SERVICE BULLETIN

NUMBER: 15-162-13R

SUBJECT: Service Procedure for Replacement of the Bluetooth
 Microphone for Kenwood Audio / Navigation Systems

Impreza, WRX & STI

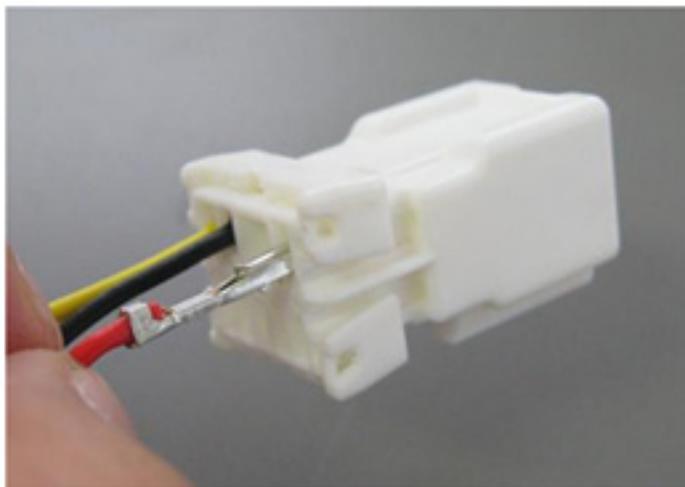
- Remove all three wires from both the replacement and the vehicle's original microphone harness connectors.
- Reinstall the terminals of the replacement microphone's harness into the vehicle's original microphone harness connector as shown below. The connector is being viewed from the front in these two illustrations.
